GEK-45402
INSERT GEK-34059

A. C. PILOT WIRE CHECKING RELAY FOR TWO WAY TRANSFER TRIP

TYPE BBA99AB001E

Fig. 1 (0257A8352-0) Fig. 1 Internal connections diagram for the BBA99AB(-) Relay

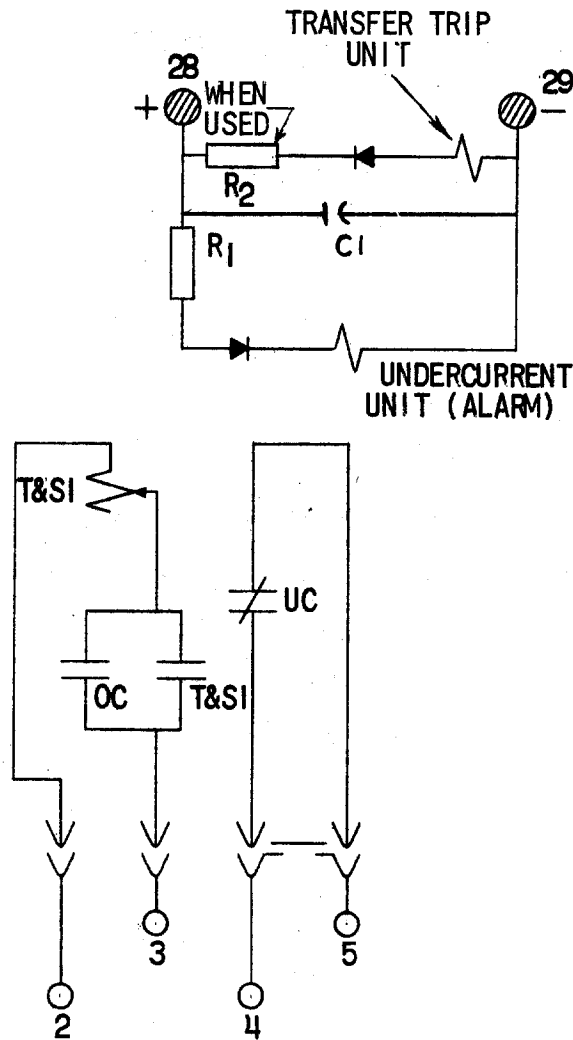
Special relay BBA99AB001E is similar to relay BBA11B except as follow

1. The internal connections are as shown in Fig. 1 of this supplement.
2. The trip unit pickup is 5 milliamperes D.G.
